City of West Linn  
**PRE-APPLICATION CONFERENCE MEETING**  
**FINAL REVISED Notes**  
February 17, 2011

SUBJECT: A Class I Variance (possibly), two Class II Variances, Water Resources Area (WRA) Permit, and Permit to Enlarge/Alter a Non-Conforming Structure for garage at 2013 Marylhurst Drive

ATTENDEES: Applicants: Mary and Bruce Wood  
Staff: Tom Soppe (Planning Department) (notes co-drafted by Peter Spir)

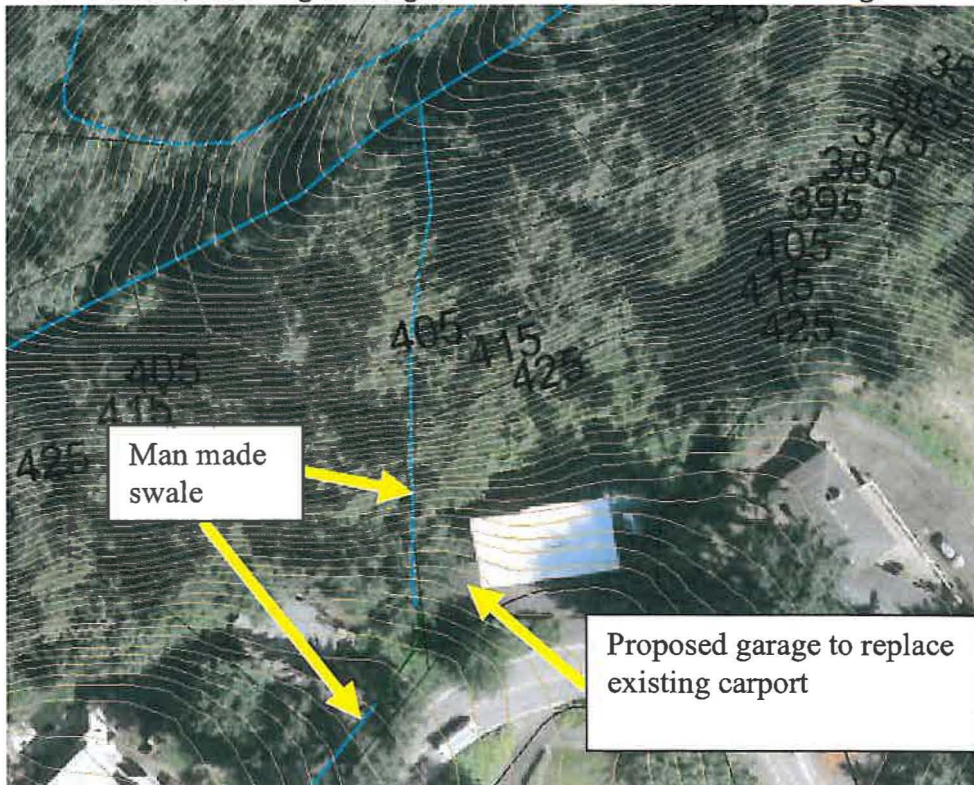
The water travels in a shallow man-made swale and pipes on the north side of Marylhust Drive before turning 90 degrees through another man-made swale (about four inches deep) along the west edge of the Wood property and eventually emptying into Robinwood Creek below. The amount of water in the swale is very slight. Staff visited the property one day after a three-inch accumulation of rain in the previous 48 hours, and the swale was just damp with no running water.

Apart from its shallow depth, another indication of the extremely limited flow of water in the swale on the west property line is the fact that if this channel carried any significant water flow one would expect that the water's erosive qualities to scour down to the underlying soil and rock. That is not the case here.

Based on staff's visits, staff finds that this channel meets the definition of a roadside drainage swale for that portion that is clearly man made adjacent to the west property line. The usual transitions and setbacks associated with a WRA do not apply per CDC 32.020(C):

(Please note that an alternate interpretation could be made: that the swale diverges from the road, meaning this segment is not "roadside" and not eligible for exemption.)

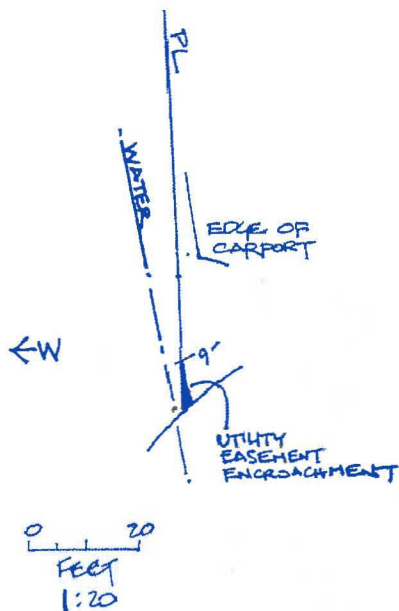
There is a six-foot wide utility easement that per the easement's legal description lies to the west of the west side lot line. The easement has a City six-inch water line buried in it. Engineering staff conducted a water line "locate" (2-14-11) and marked the line in the field with blue paint.

At the edge of the ROW, the water line is one foot west of the property line. From that point north it gradually diverges from the property line to a distance five feet west of the property line, 25 feet north of the ROW near the south edge of the carport. Since the easement is usually centered on the water line, the easement is definitely fully on the property to the west at the point where development is proposed under either Plan 1 or Plan 2, even if the easement is centered on the water line and does not match Engineering's interpretation of the legal description. The only area where the easement might be on the applicant's property (if it matches the centering on the line and not Engineering's interpretation of the legal description) is at the front 9 feet of the property where the easement might zero to two feet onto the applicant's property, lessening the further north you go in the first nine feet from the ROW. This scenario is shown in the drawing below. Even if the below scenario exists, instead of the scenario where the easement is completely on the neighboring property, the easement and the water line do not interfere with either garage proposal.

In addition to this consideration, Engineering recommends that utility locates be conducted for the private utilities such as gas prior to initiation of work at this site.

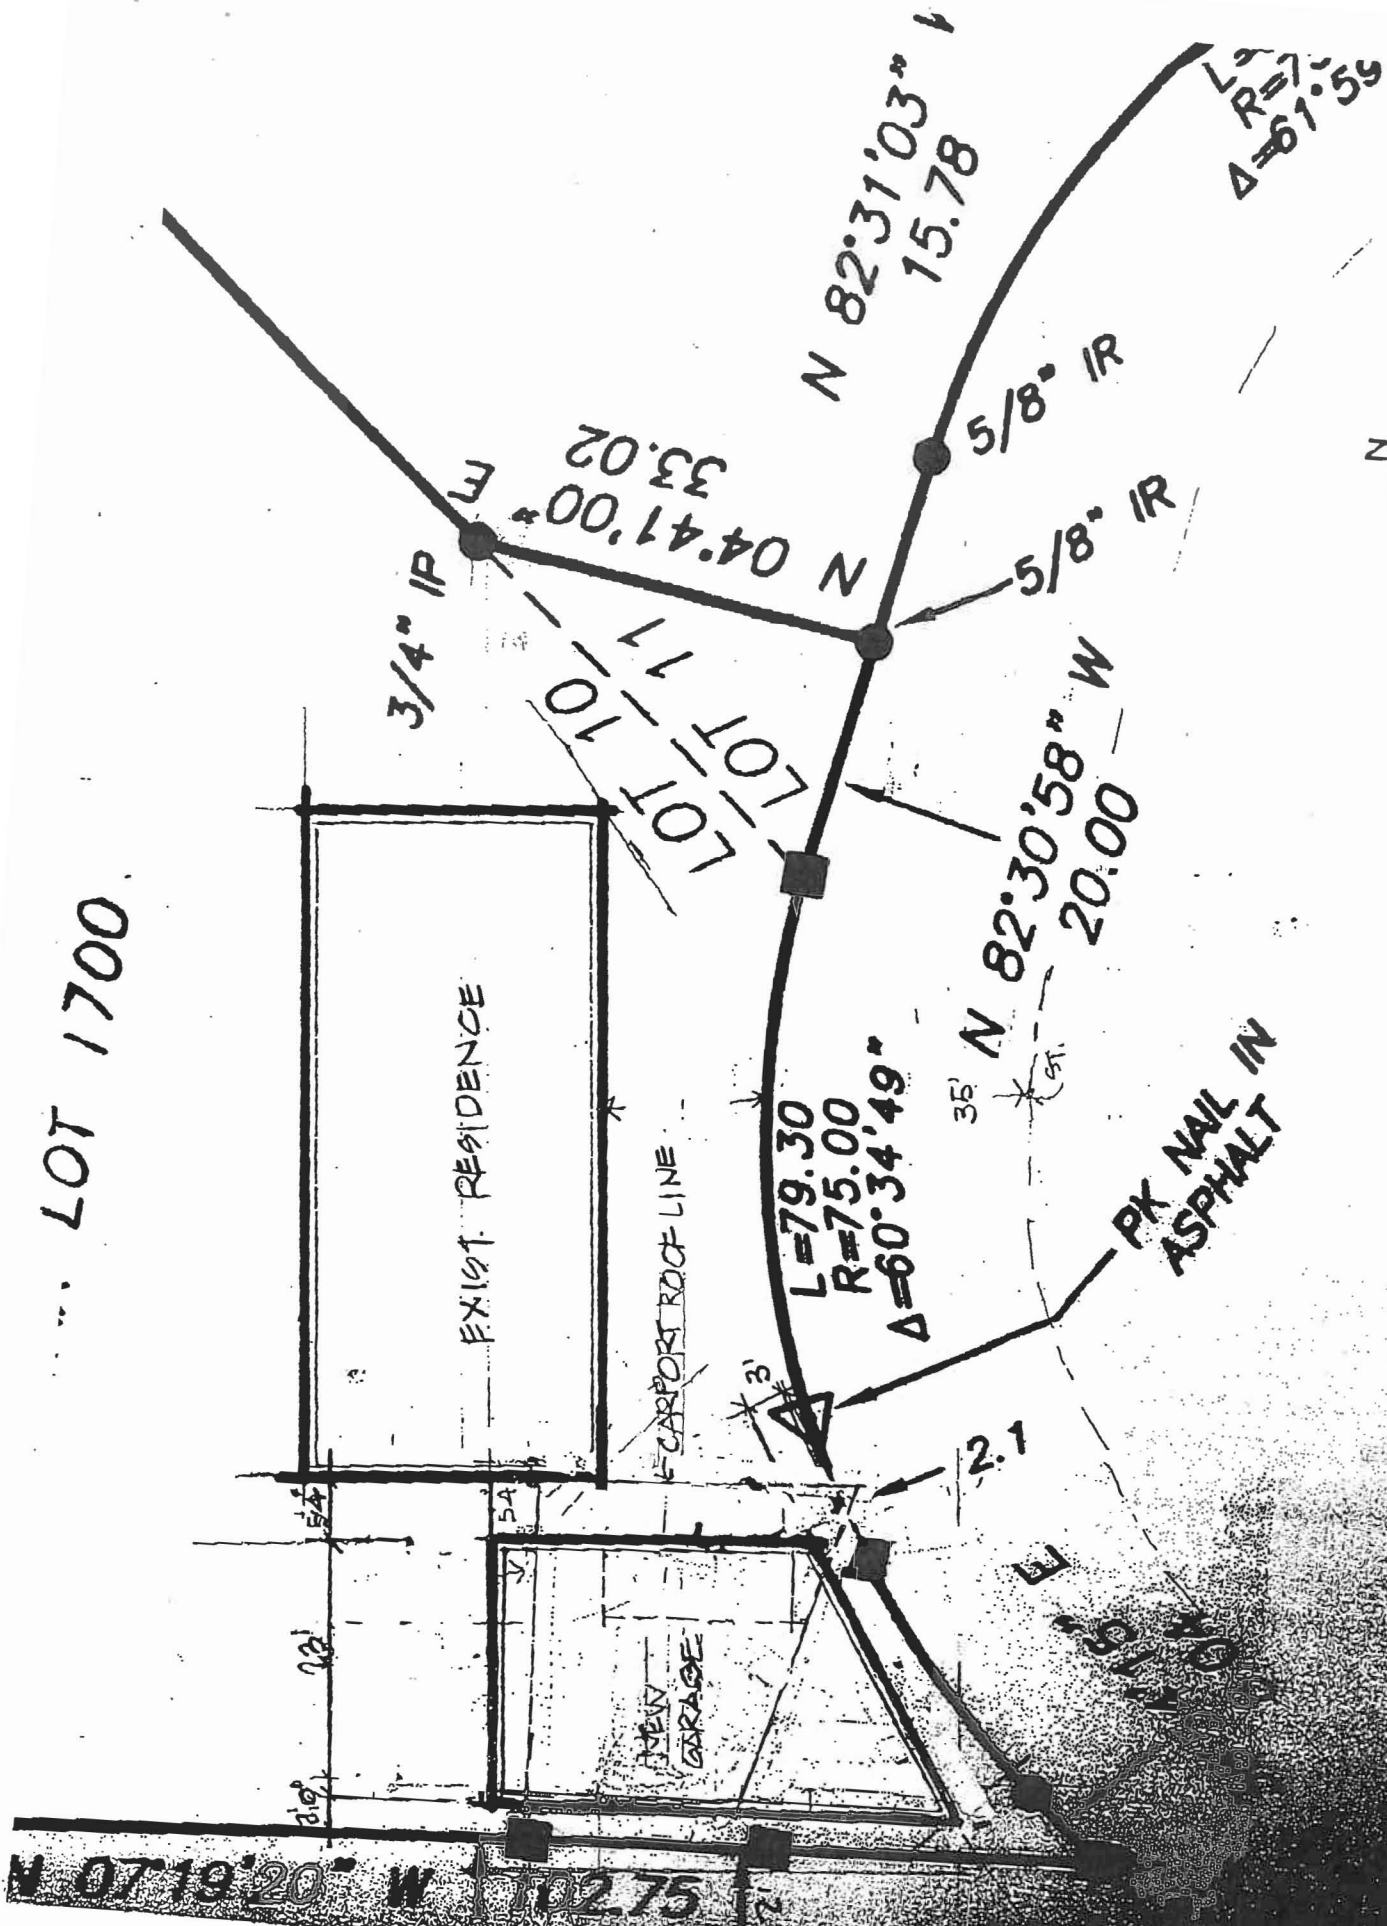
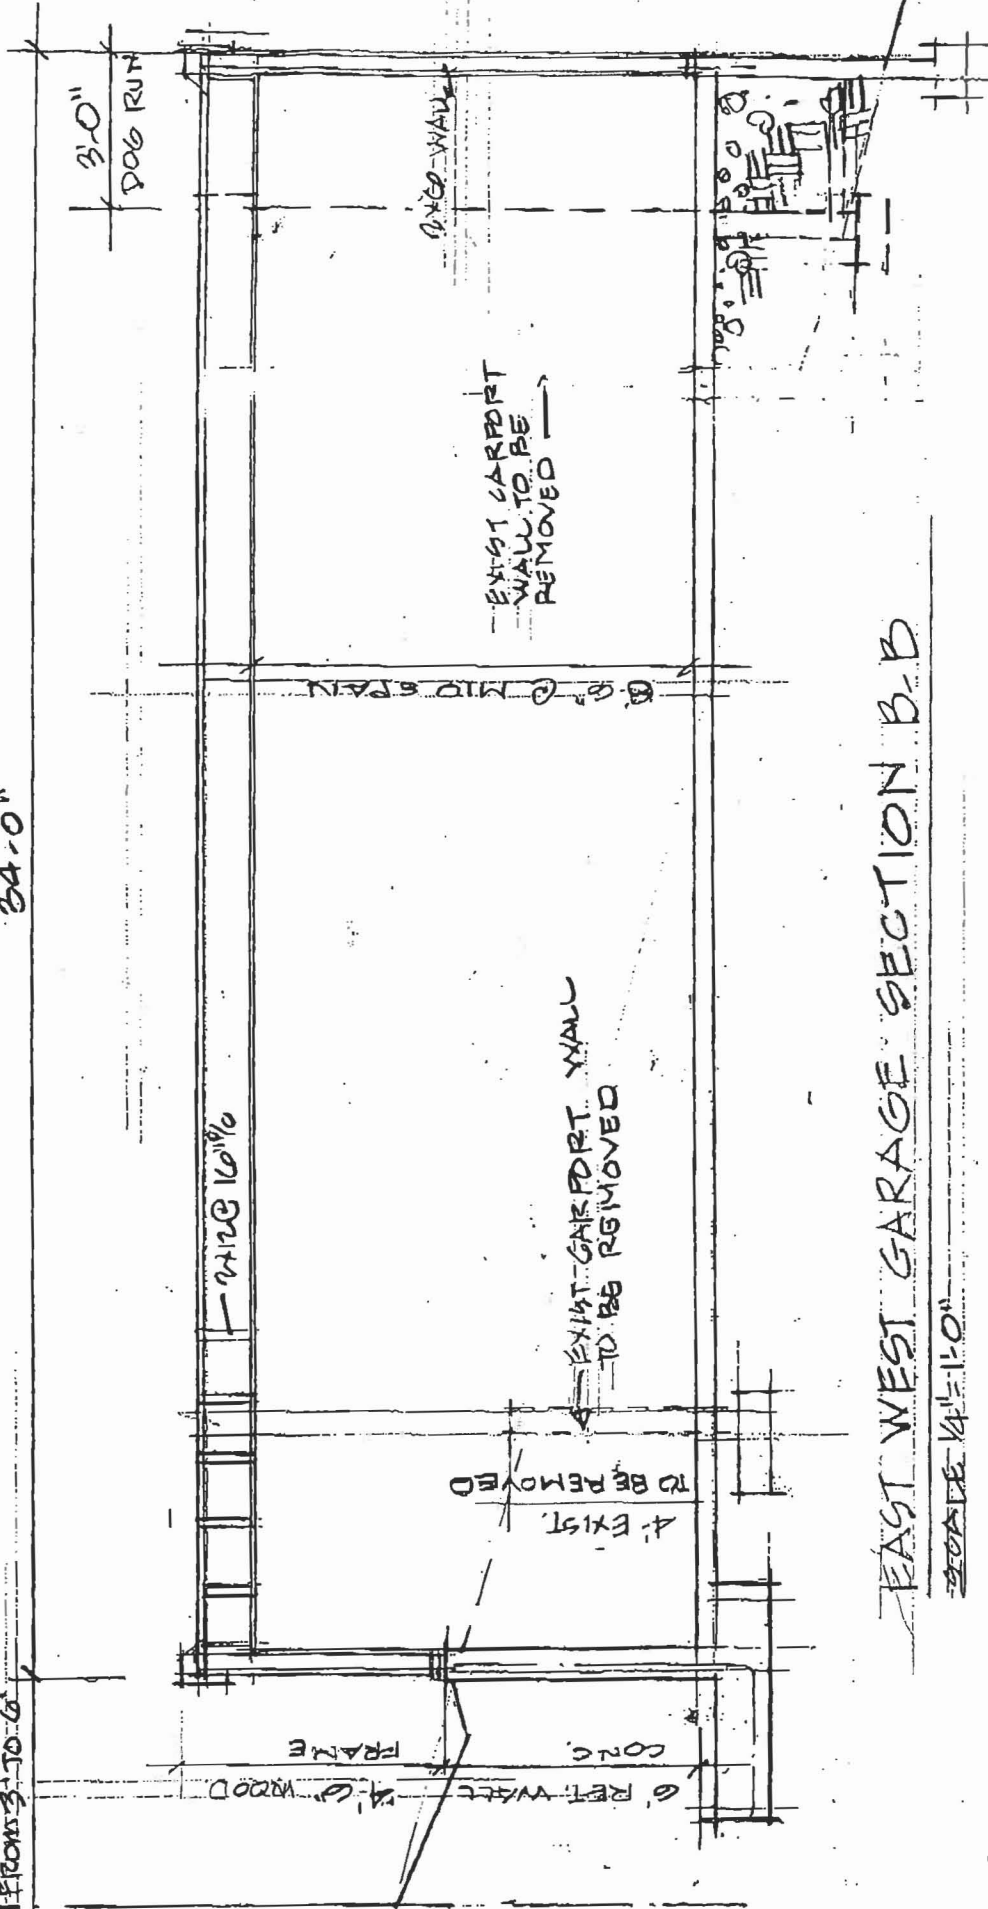
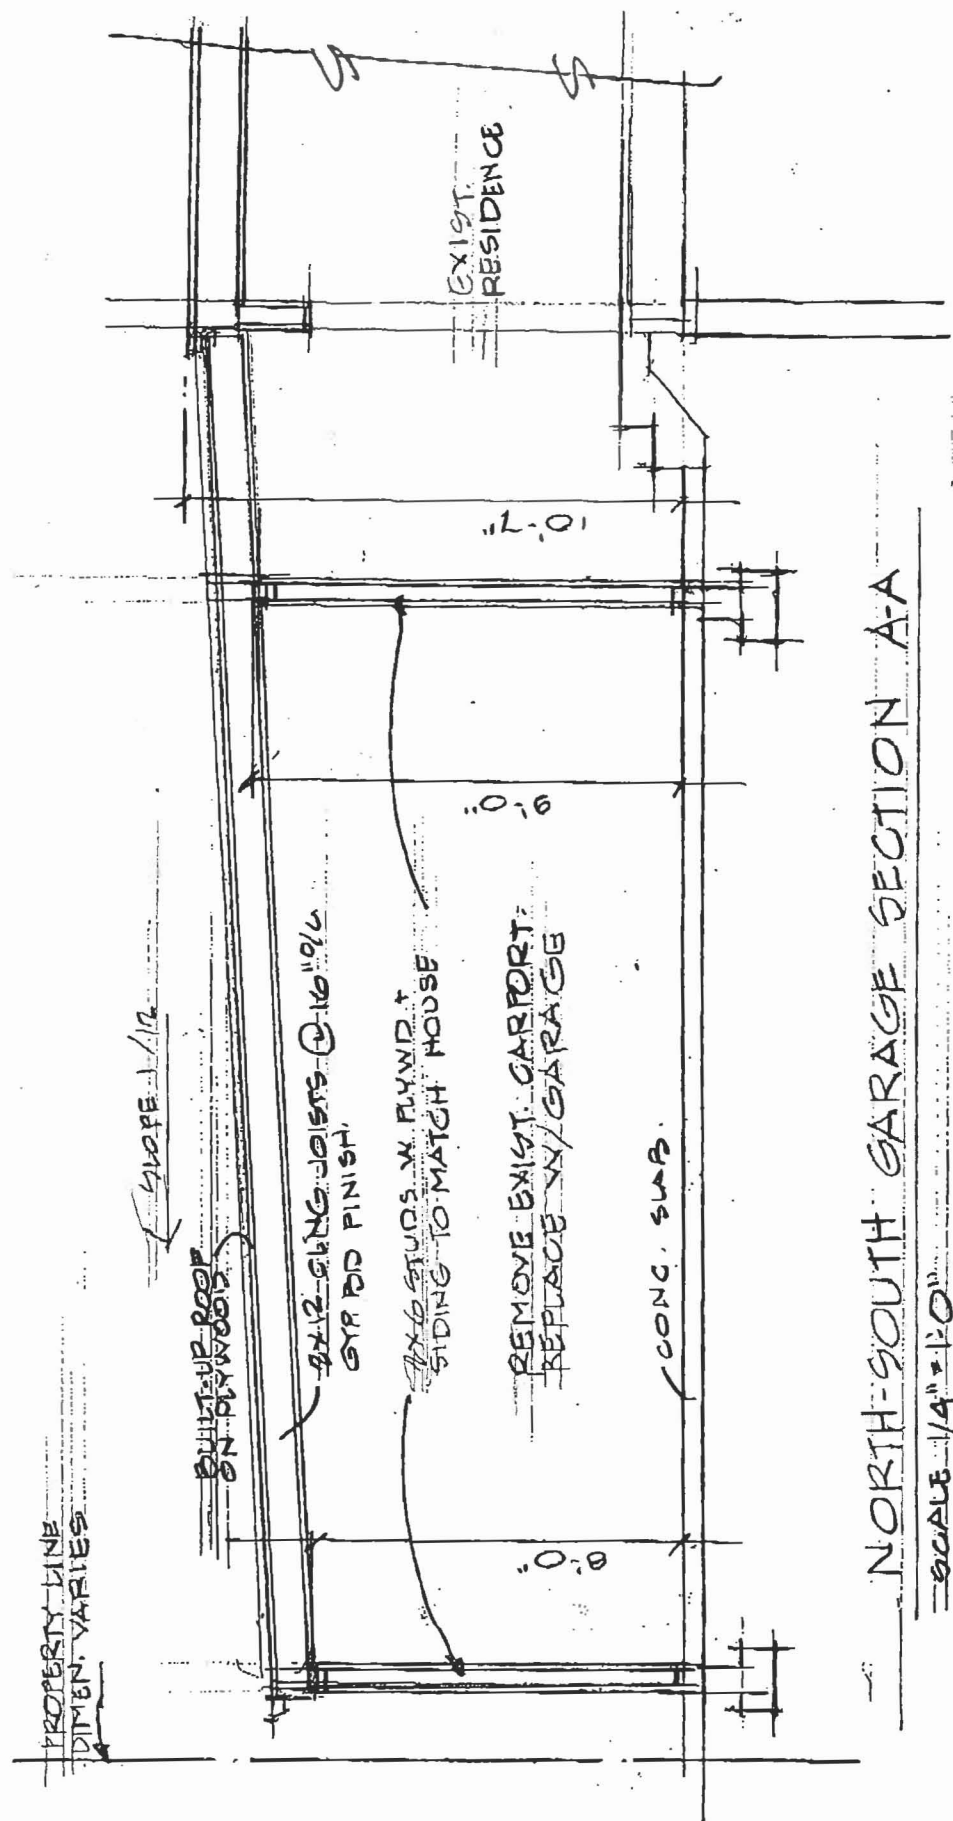
I am enclosing the revised layout for the garage.

The southeast corner of the garage is 3' from the street ROW line.

The southwest corner is 6' from the street ROW line. This is what the planner suggested so that you would not have to go for a variance for the front yard setback because of your lot slope.

The southwest corner of the garage is also 3' from the west property line and that same line follows thru to the northwest garage corner. That entire side of the garage is parallel with the property line but 3' away.

The garage roof extends 3' over the dog run. If the garage slab goes over this area we have added 3' to the north of the carport slab. That would add 69 sq. ft. in the direction of the creek below.

I have held the garage 5'-4" from the patio door as you asked.

The dotted line shows where the existing carport is located.

The west garage wall looks to be about 40' long. The east garage line f will be about 27' long. You should have about 770 sq. of garage area with this scheme. Your carport was actually about 640 sq.

The advantage of this new layout is that the carport, which has extended over the street ROW no longer does this and the garage is a minimum of 3' from that same property line now.

You now only have a side yard setback to appeal and that adjacent property is a drainage ditch which has a 30' property with that cannot be infringed upon.

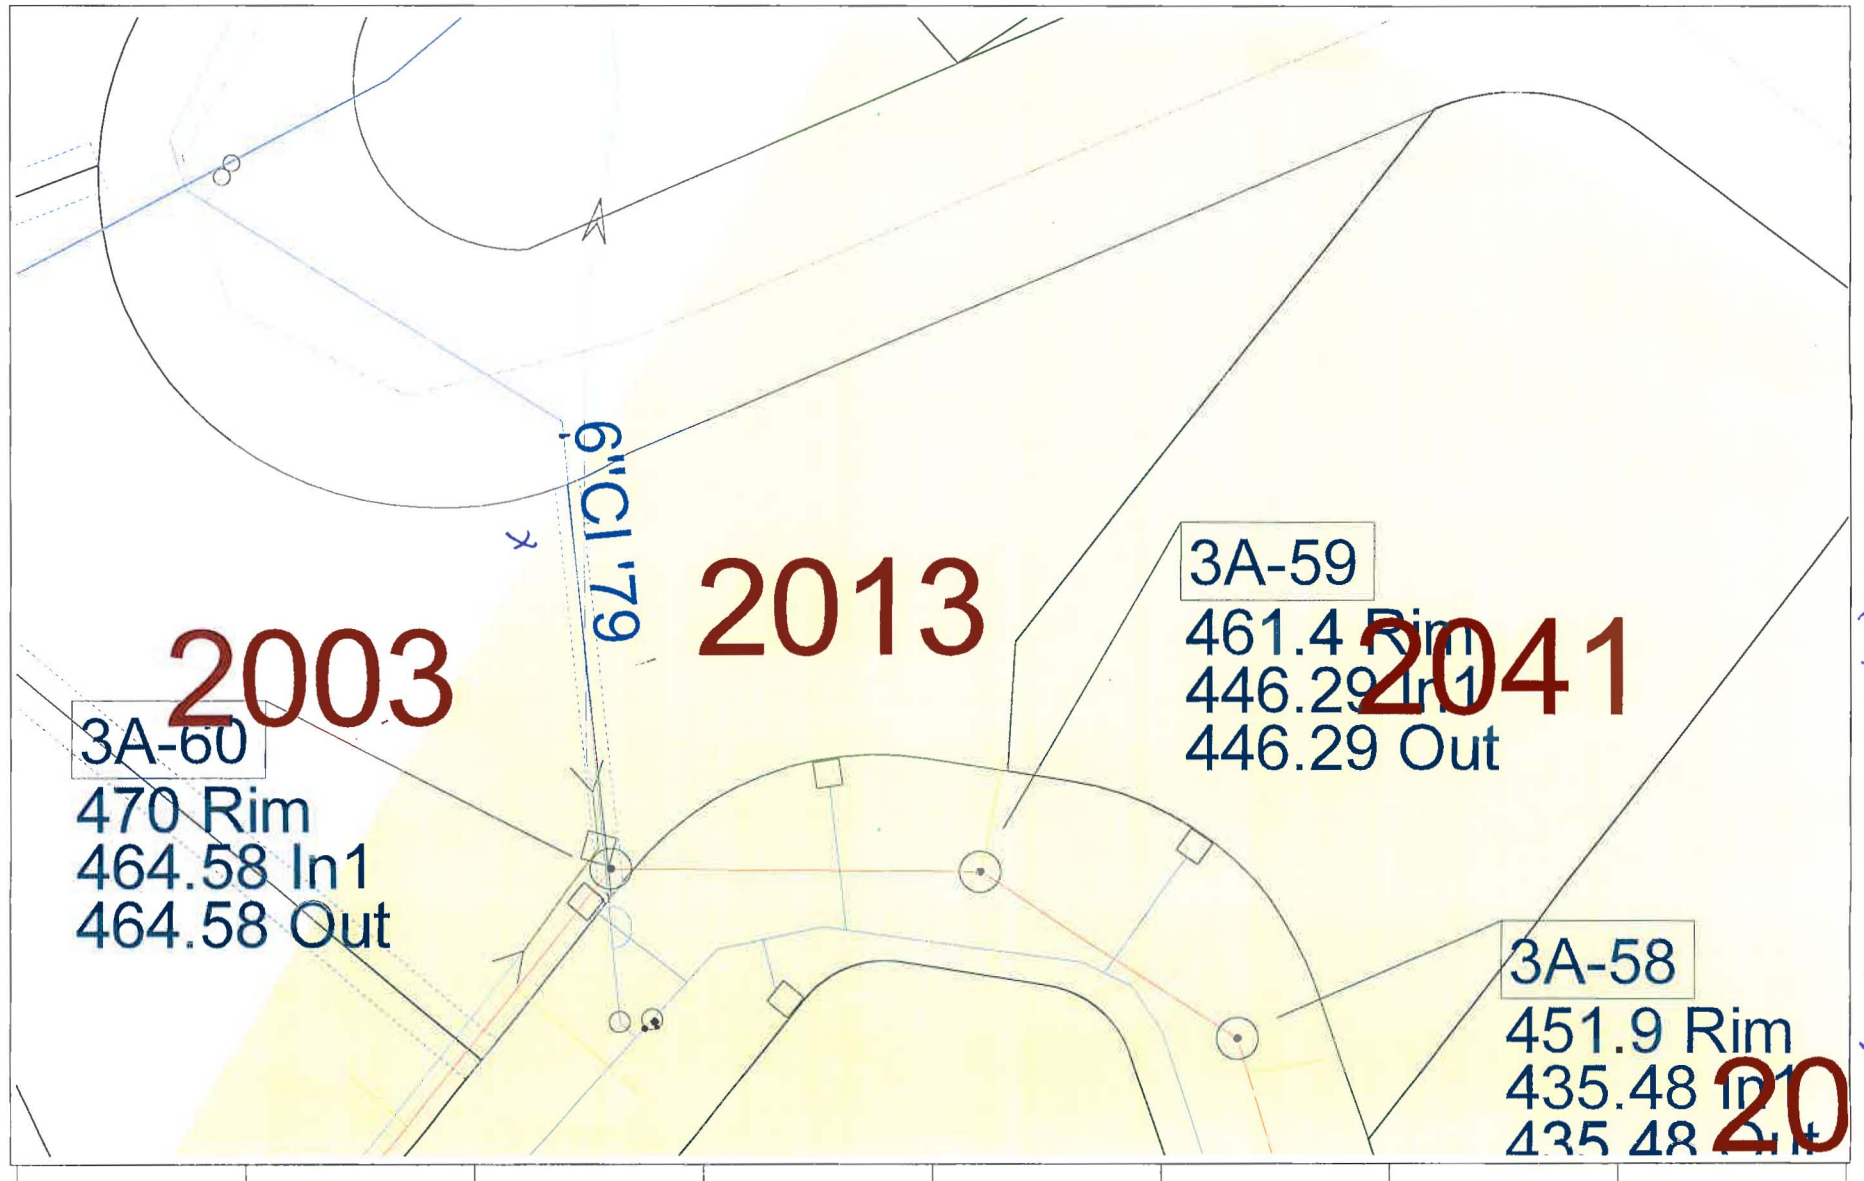
water line is easement?

"Westerly of"

6 feet going W. of current lot line  
 "in Lot 10 means original lot 10"  
 No easement on property
